2.1 Distribution of the Draft EIS/EIR

2.2 Comments on the Draft EIS/EIR

¹ See Attachment 1: Letter from Douglas Hansen, Director of Strategic Planning, YTI, to Mr. Chris Cannon, Environmental Management Division, Port of Los Angeles. Dated September 18, 2014. Re: Responses to Comments on Port of Los Angeles Draft EIR/EIS Report- Berths 212-224 Container Terminal Improvement Project

Figure R.7: Mitigated Proposed Project Federal 1-hr NO_2 : Operation

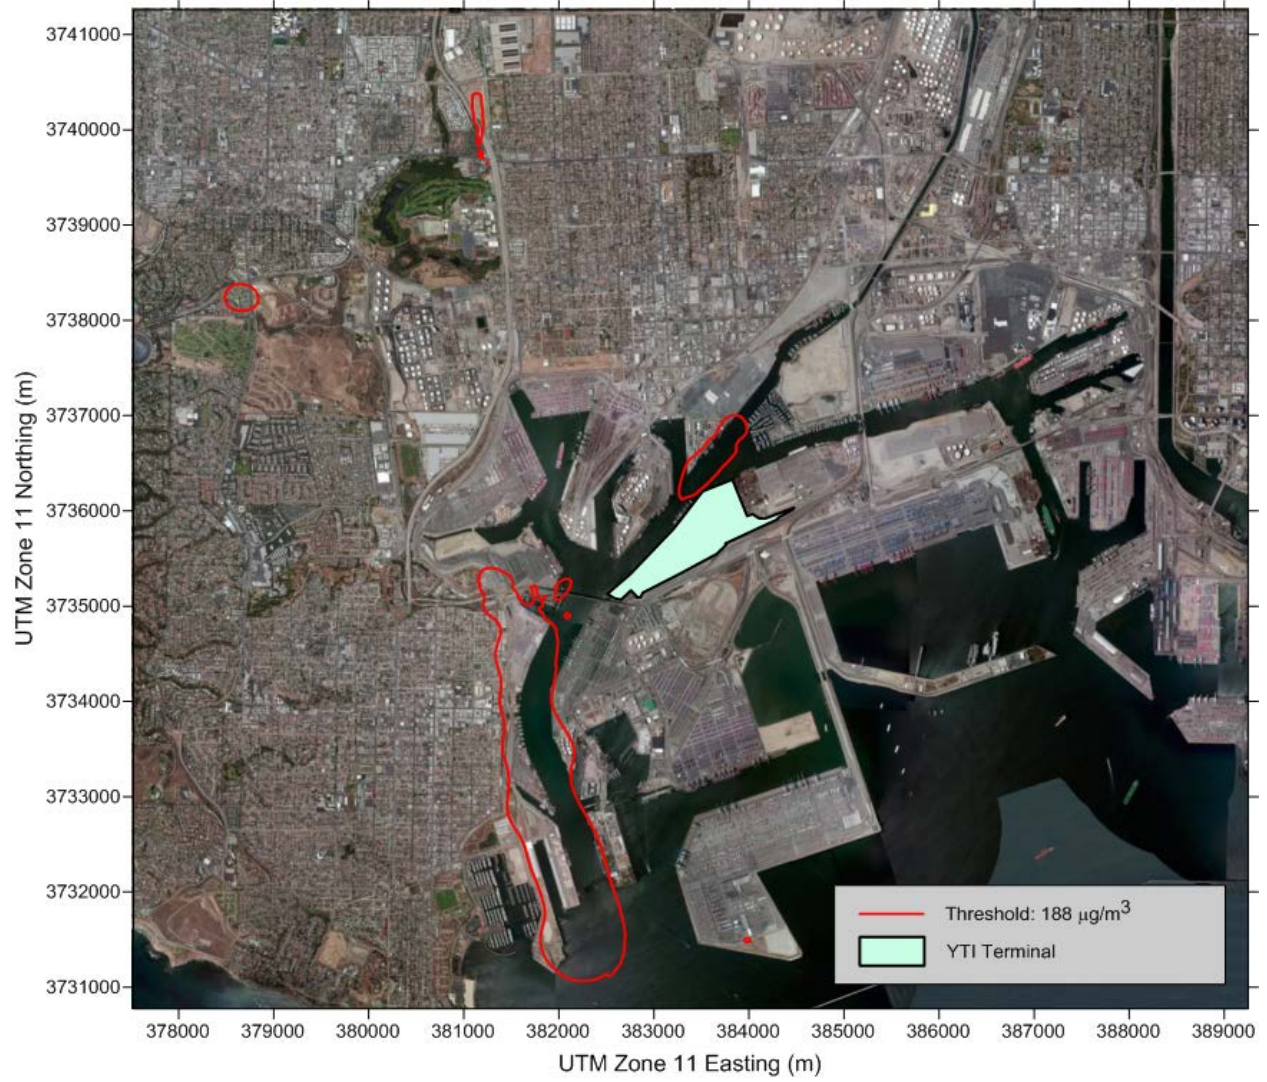
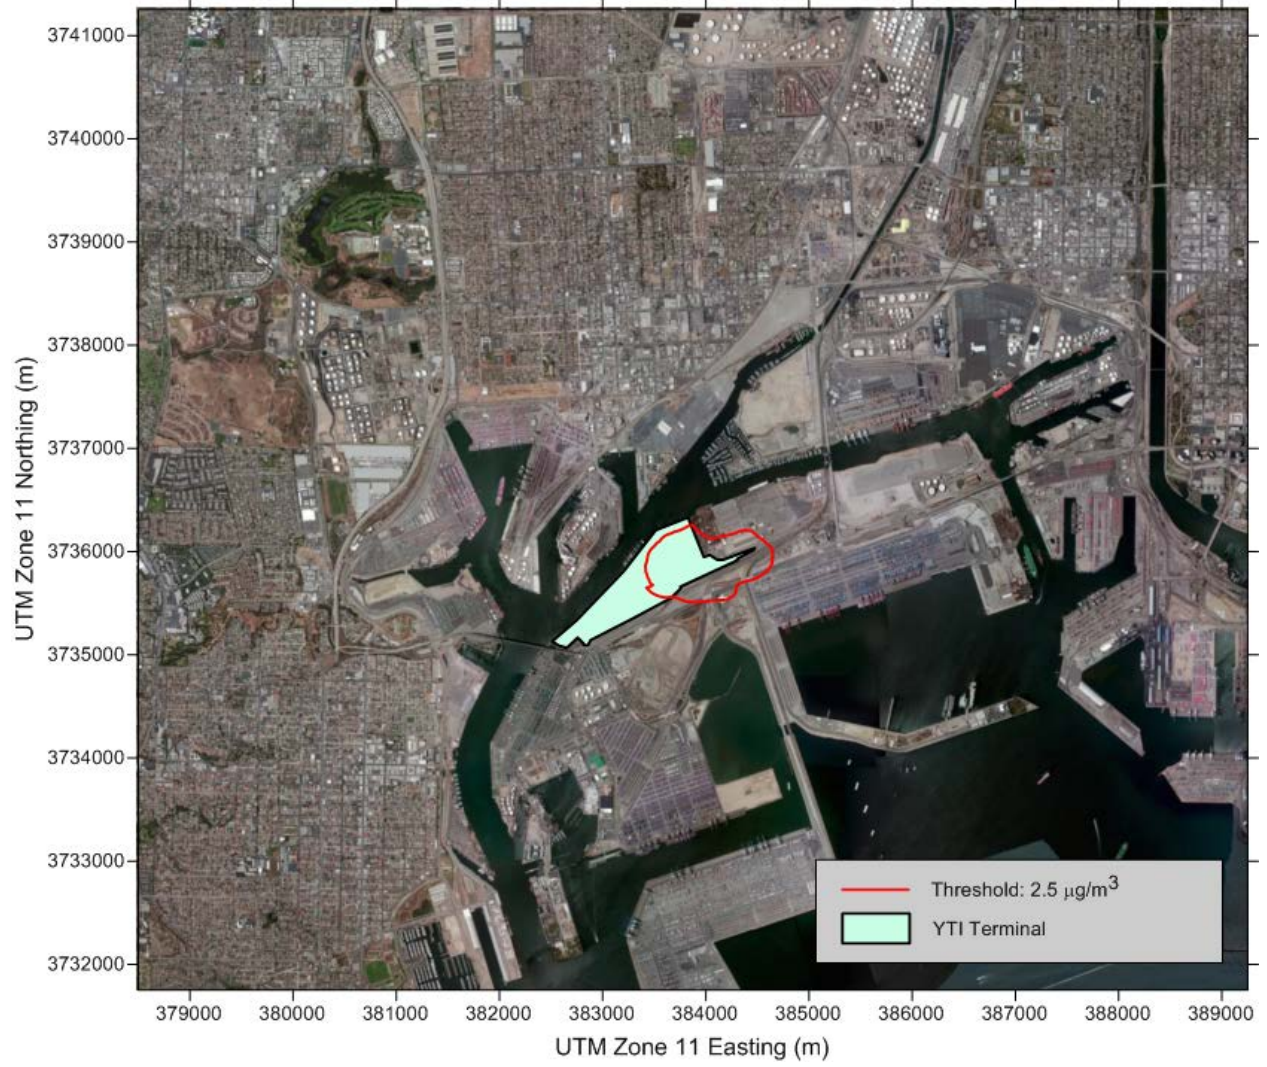
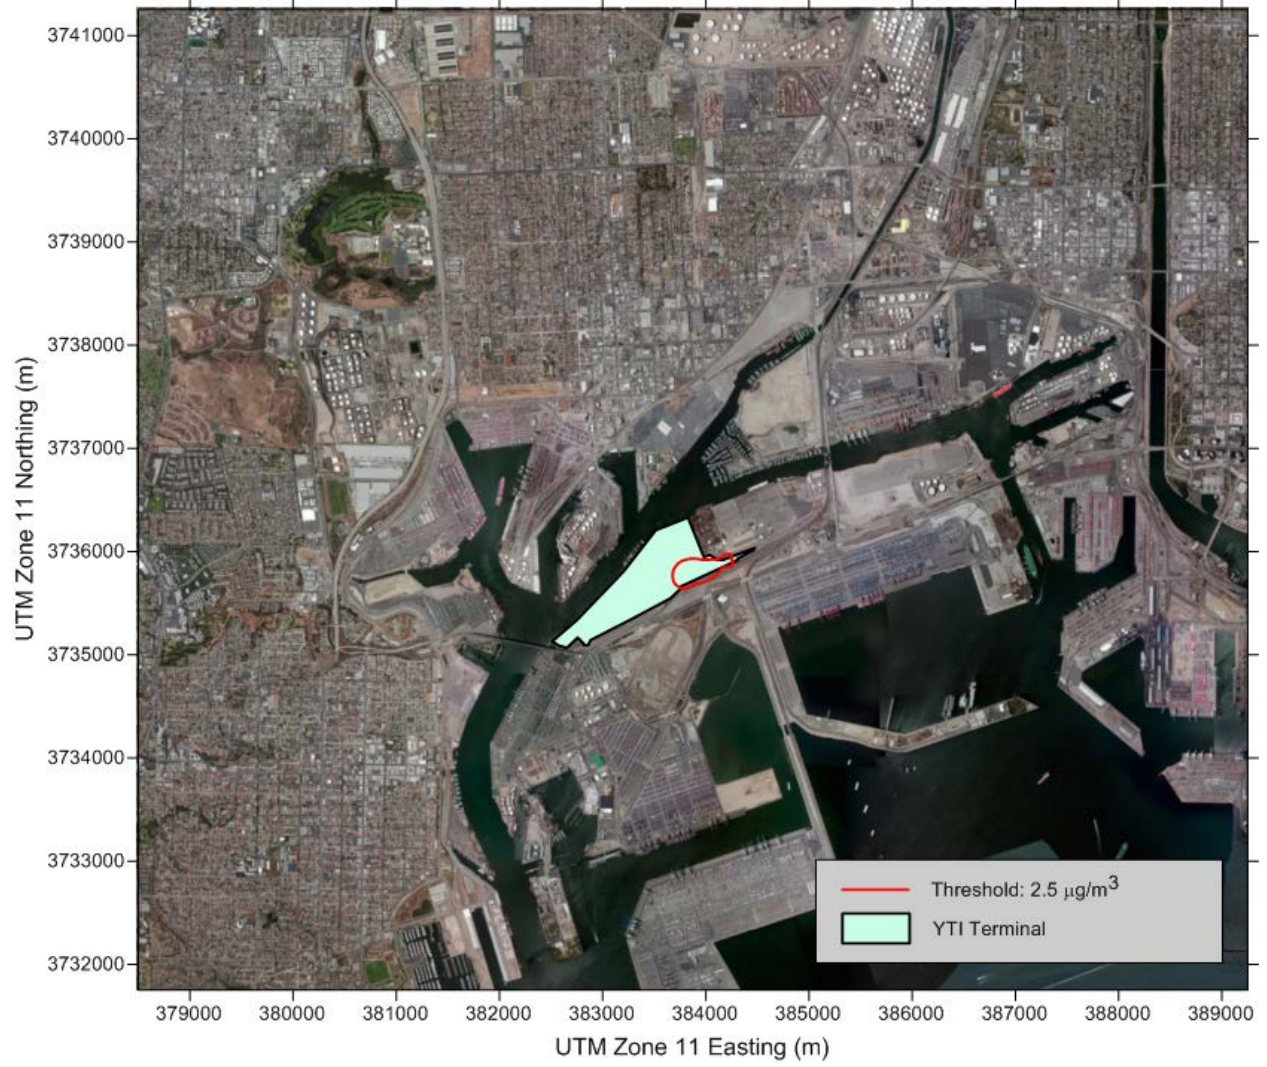
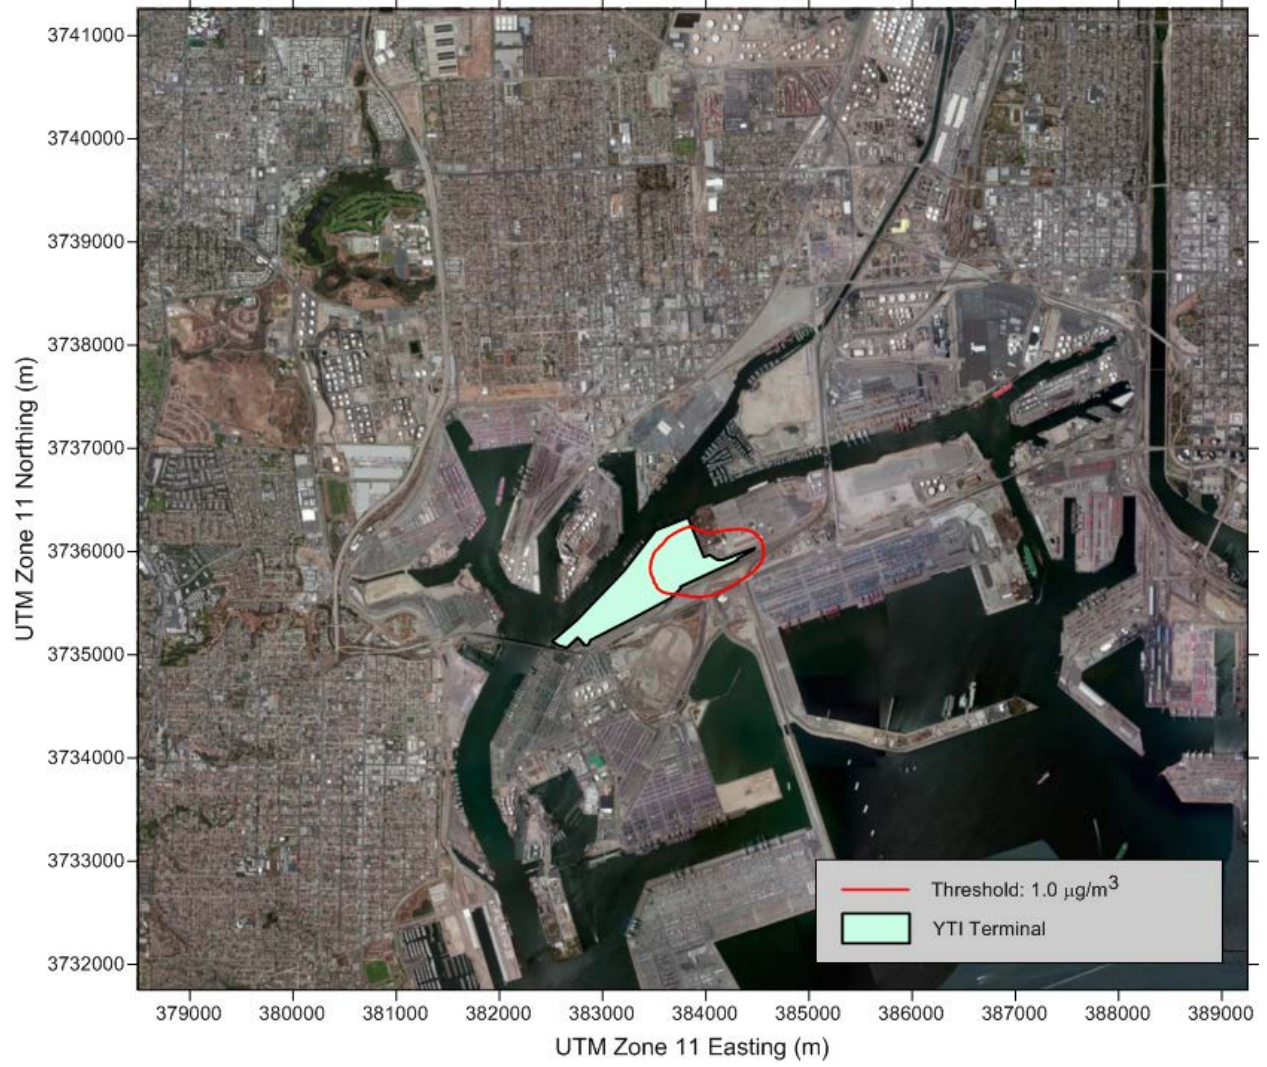
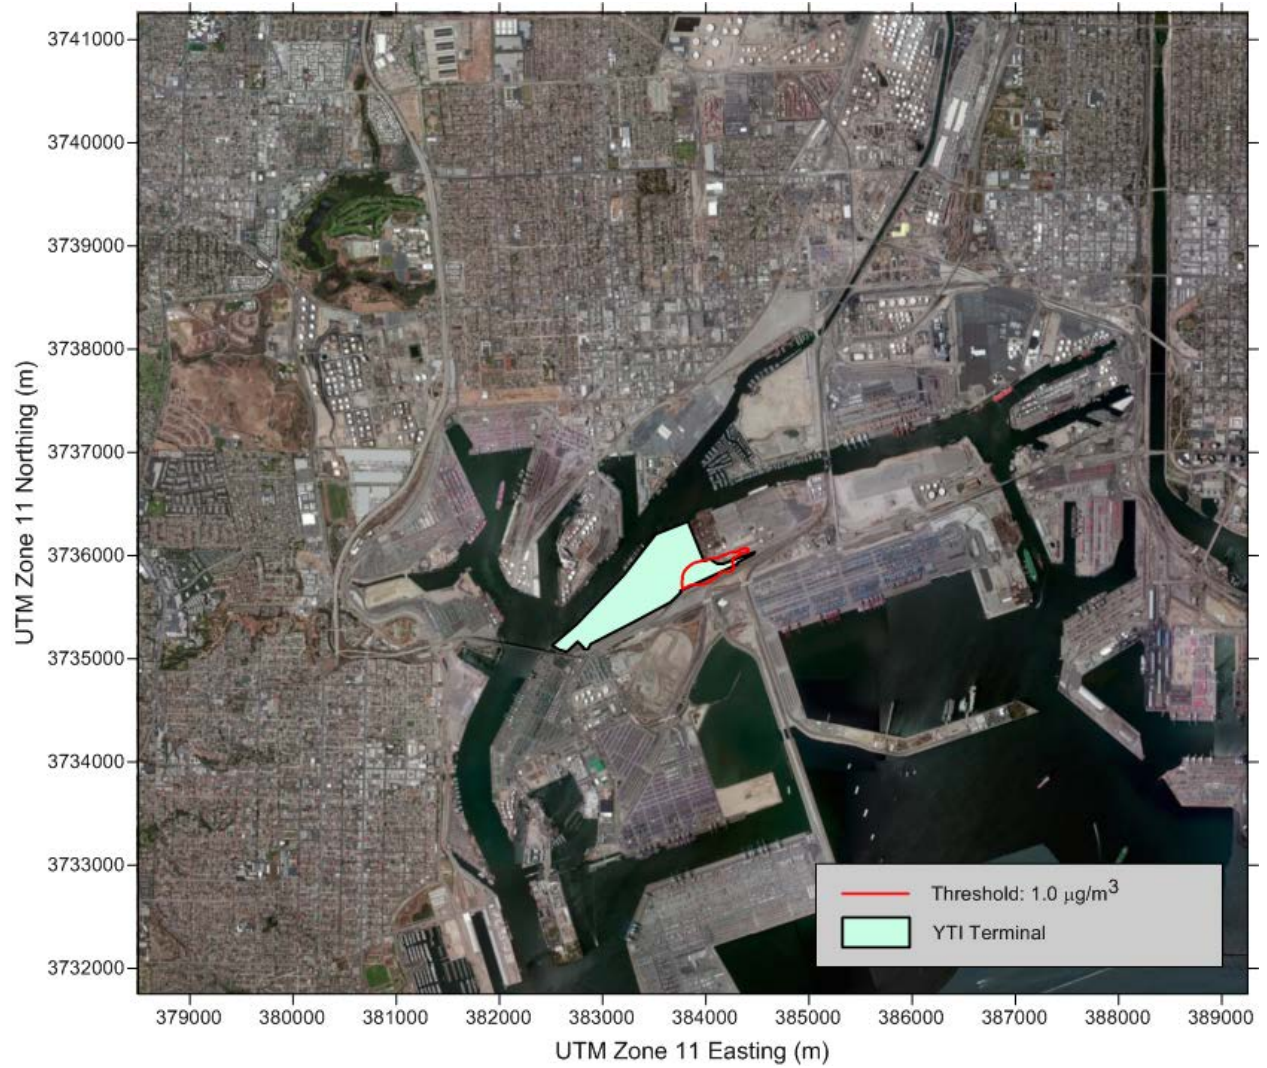
The EIR and appendices contain tables and text describing the dispersion modeling of criteria pollutants, however no maps are provided showing the extent of those impacts. The only maps provided (e.g., Figure 3-16 in Appendix B2) only show the points of maximum impact. Maps that show contours of all areas affected
